# APPENDIX G: DESIGN INTEGRITY REPORT

**Pitt Street North Over Station  
Development**

State Significant Development,  
Development Application (SSD DA)

SMCSWSPS-URB-OSN-DM-REP-000007

*Refer Architectural Design Report Section 2.12.*

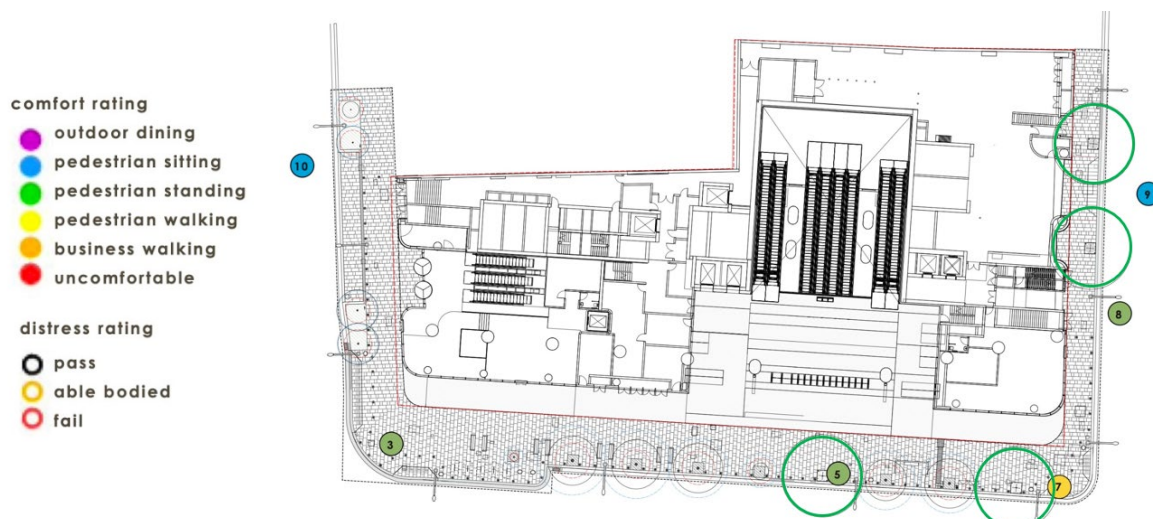
2. Tree planting is supported with further City of Sydney coordination. Further refinement required including the development of a strong set of principles to ensure a positive outcome.

- In depth wind studies have been undertaken by wind engineering in order to ascertain the impact wind will have on the trees and their ability to grow and thrive. The analysis concluded that the existing wind conditions and proposed building massing will not negatively influence the viability of the street trees.

- In addition to the introduction of infill street trees, tree planting has been proposed on the podium roof terraces on levels 10 and 11. The proposed planting is offset from the perimeter of the podium to allow façade maintenance with trees glimpsed from the streets below. The raised planter beds offer 800mm soil depth for small scale trees.
- Wind studies have also been undertaken for the level 10 and 11 terraces, and early results proposed the exclusion of trees on the south-easterly corner of the level 10 terrace due to the wind conditions during peak events. As a result, trees are only located along the western, southern and north-eastern perimeter of the podium roof terraces as indicated in the diagram below.

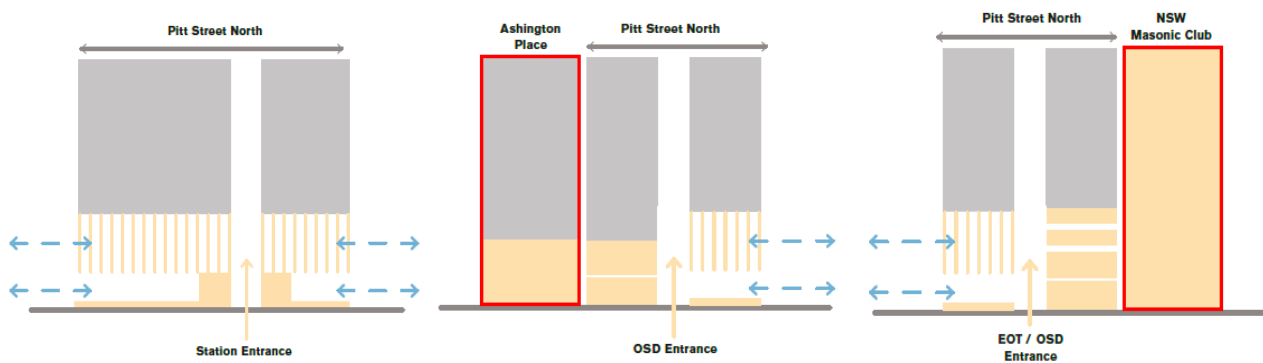
5. Further refinement of the facades: detail and materiality. This includes further attention to the detail of the sandstone at ground level to achieve an appropriate civic response.

- The PSN site is located centrally within the wider Town Hall Precinct, an area which is dominated by a significant number of civic heritage-listed sandstone buildings. Most buildings have predominantly solid facades with central entrances within an overall symmetrical building composition.

- Over the past few years, modern infill-developments have been erected in-between the heritage-listed buildings. These buildings have been carefully slotted in by using masonry and sandstone elements within the design of their facades. While mostly taller than the existing heritage-listed buildings, the more modern facades are categorised by displaying striking good balance between solidity and permeability, activating the street facades while seamlessly integrating into the existing streetscape.

## Heritage Displays

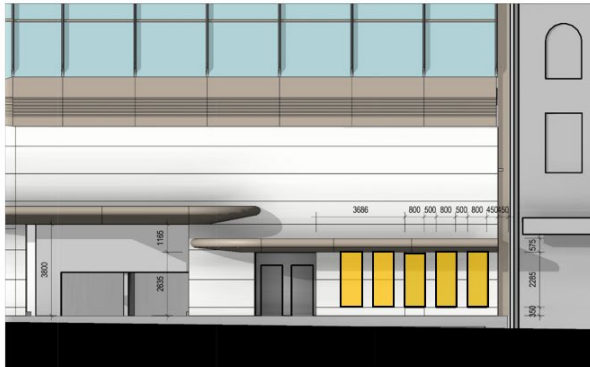
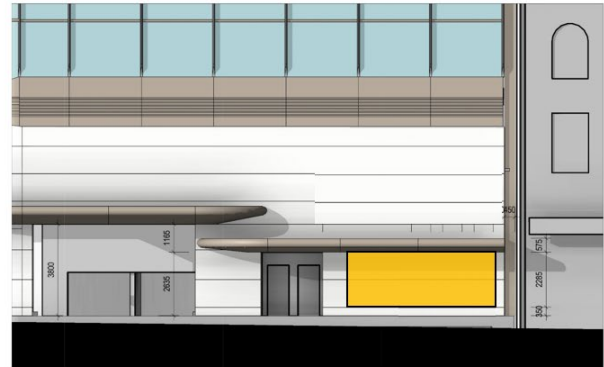
- The Panel noted that they accepted the modifications to the facade Castlereagh Street to improve design relationships with adjoining buildings and heritage display strategies. The Panel also mentioned that they looked forward to the developed design of heritage interpretation panels. The Panel didn't specifically select one of the two options at the time.

- During DRP No.3 on the 17<sup>th</sup> of December 2019, the design team presented 2 different options to the Design Review Panel; Option 01 shows 5 individual display case of a similar size. While option 02 showed one large display case, as indicated in the below diagrams which were presented to the panel.

## Wind Analysis - CPP

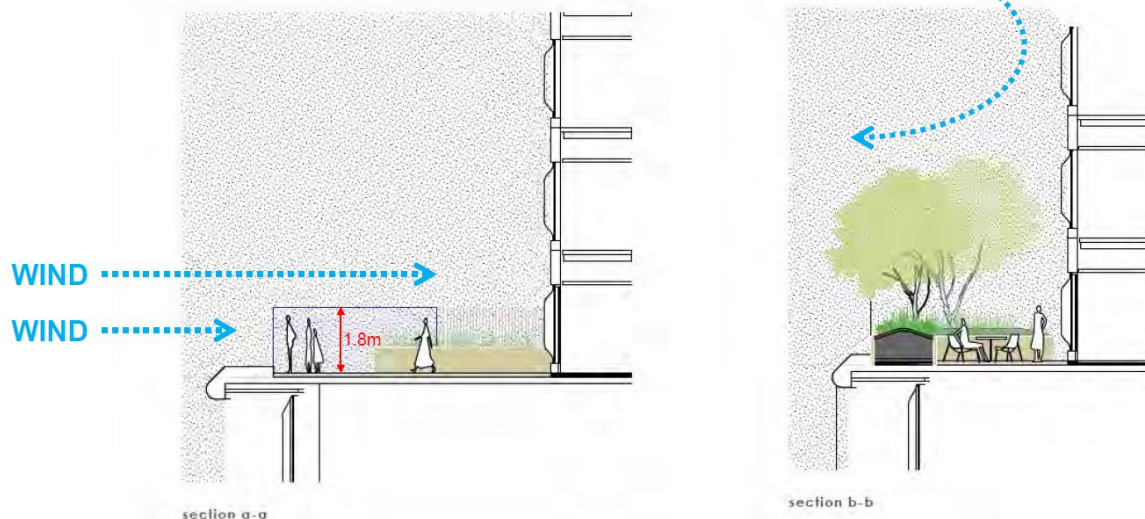
The feedback from the DRP panel was as follows:

## 2) Materiality of façade - Bronze finish and Sandstone

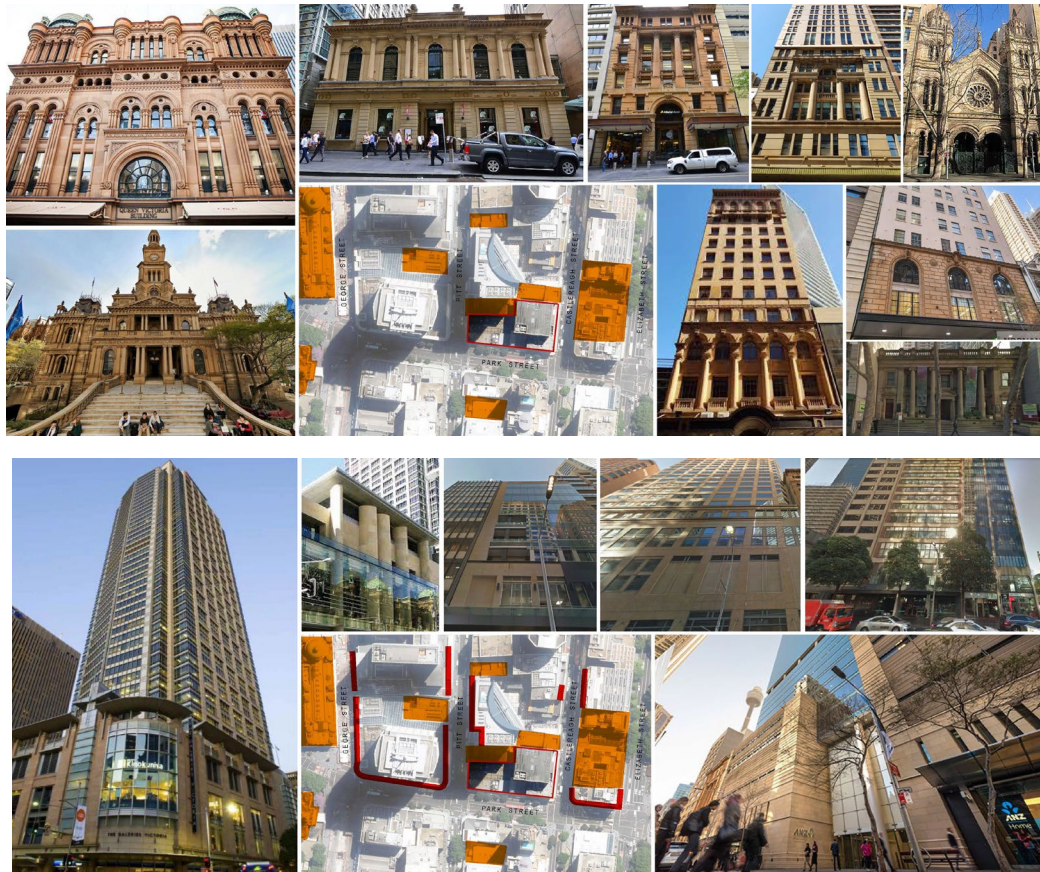
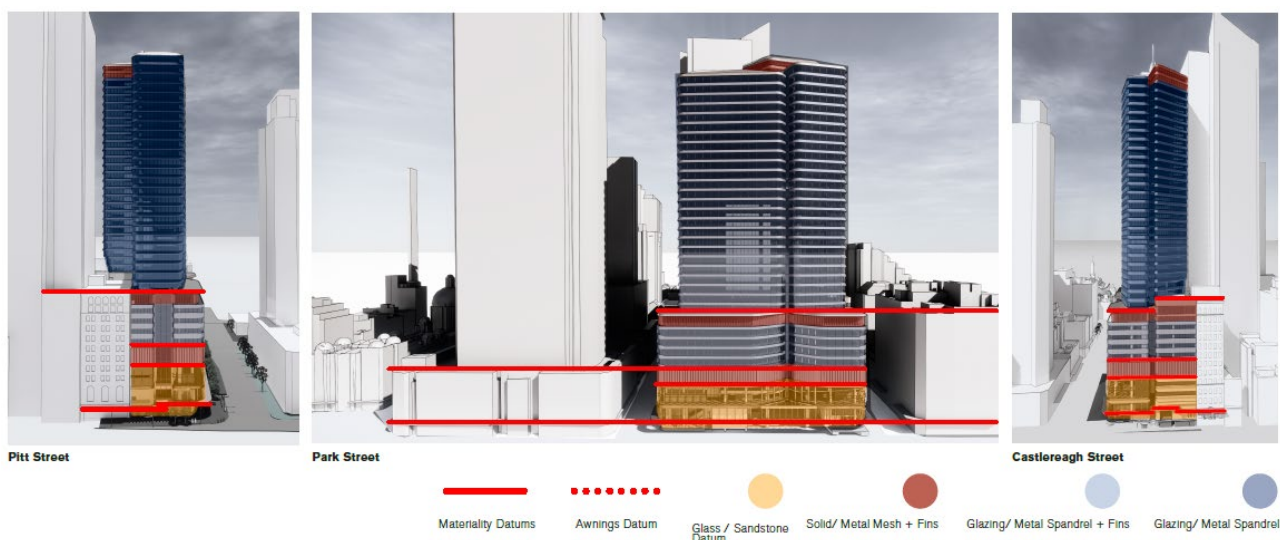
The final notes from the DRP panel after meeting No.9 concluded that; the Panel supports the product warranty evidence to demonstrate durability and is looking forward to seeing samples of the proposed finish in all variant façade forms when available on site.

The design team initially presented the approach for the materiality of the building the first DRP Presentation on the 15<sup>th</sup> of October 2019, and in slightly more detail during DRP No.2 on the 19<sup>th</sup> of November 2019. Both presentations were in alignment with the OSD Design parameters laid out for the project during the RFT phases, taking cues from the scale and character of existing sandstone heritage buildings and the more recent masonry infill developments, with the new building complimenting this existing city context in terms of façade composition, materials, colour and texture.

The design intent was to keep sandstone finishes limited to the 'masonry plinth' area which relates directly to adjacent buildings on Park Street, as the height of the predominantly stone-clad architecture in the vicinity of the site is limited to 2-4 storeys, approximately aligning with an RL between 46.200 and 48.000.

#### **3) Setback/ lightwells to Ashington Place**

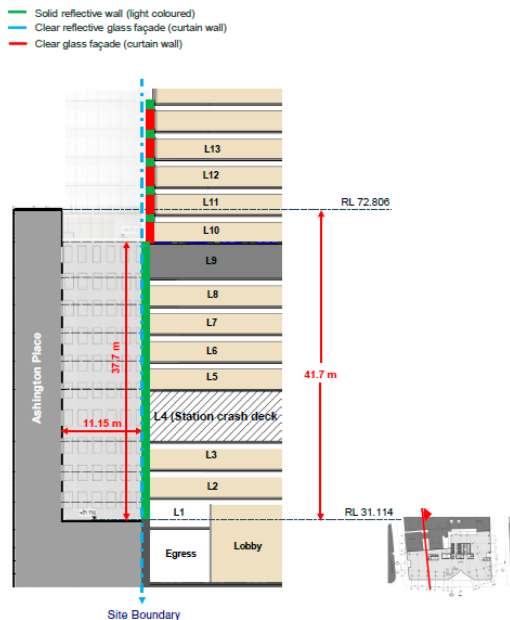
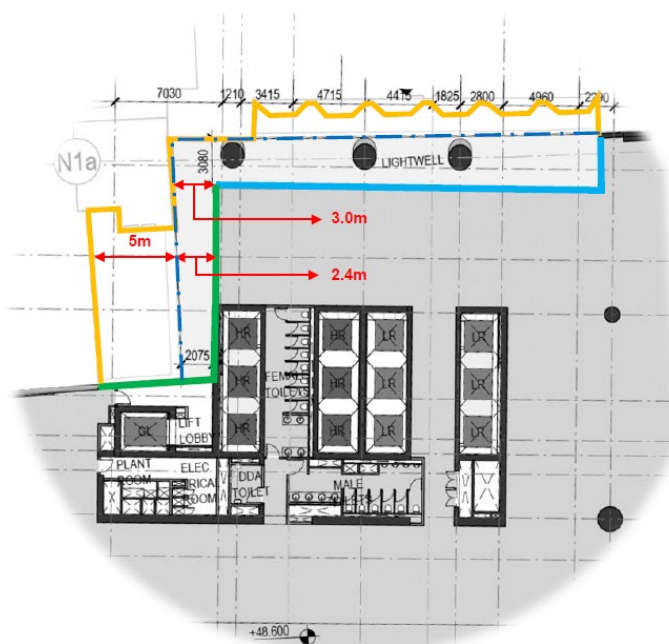
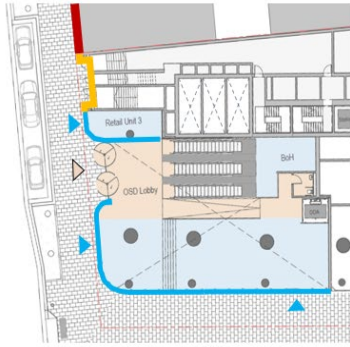
The final note from the DRP panel listed that the panel members supported the proposed approach to the materiality of all Ashington Place lightwell facades.

The northern facade of the OSD podium and tower near the North-western corner of the site is immediately adjoining the PSN site boundary and thus providing a set-back of 0m. In line with the PSN Design Parameters set for the development, the proposed podium and tower facades from level 1 to 9 are required to be clad in reflective light coloured solid materials to maximise daylight access into the Ashington Place commercial offices surrounding the lightwell, with clear glazing proposed from level 10 onwards, as shown on the diagrams below.

As such, the design of the facades which are facing the heritage lightwell with Ashington Place fully complies with the project requirements established in the OSD North Design Parameters during the RFT phases of the project.
